IN THE MATTER of Ashbourne (FTAA-2507-1087)

**STATEMENT OF EVIDENCE OF GUNASANTHA (SANTHA) AGAS
ON BEHALF OF THE MATAMATA-PIAKO DISTRICT COUNCIL**

Water and Wastewater

APPENDIX 2: WATER AND WASTEWATER SERVICES MEMORANDUM

14. A map of the development stages used for modelling is shown below:

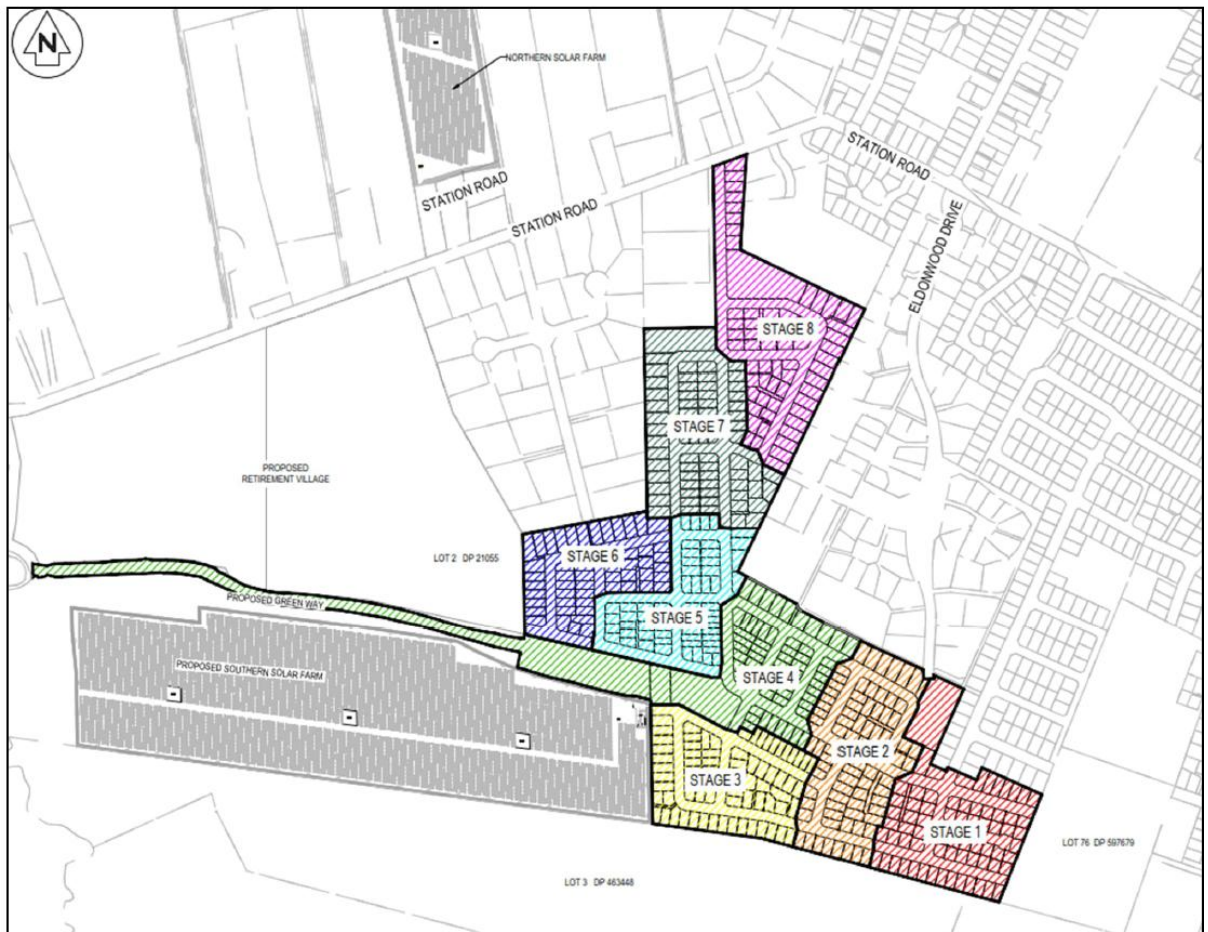
12. A high-level water modelling assessment using MPDC's calibrated hydraulic model has been carried out to understand the impacts of the proposed development on MPDC's existing and proposed water infrastructure. Water demand provided by Maven Consultants for each stage was used for the modelling.
13. Three scenarios were considered for residential developments as agreed with Maven Consultants, including a base scenario for the modelling. Information provided by Maven Consultants for each stage of the development were used for modelling.

2	Residential stage 1	Existing public infrastructure is sufficient to provide minimum level of service. However, some supply pipes exceed the head-loss criteria and Internal reticulation of the development fails to provide FW2 fire flow.
3	Residential stage 1 and stage 2	Existing public infrastructure is sufficient to provide minimum level of service with some minor head losses. However, FW2 fire flow requirements within the development will not be met without upgrades. Further upgrades are required to the existing MPDC network before subsequent developments occur.

16. The overall outcome of the high level modelling indicates that the full residential development can be supplied from Matamata Water Supply subject to staged pipe upgrades in the public network. The fire flow issue within the development can be resolved by the introduction of a booster pump station as mentioned previously.
17. Further detailed assessments must be carried out to determine the network upgrade options before proceeding with detailed designs.
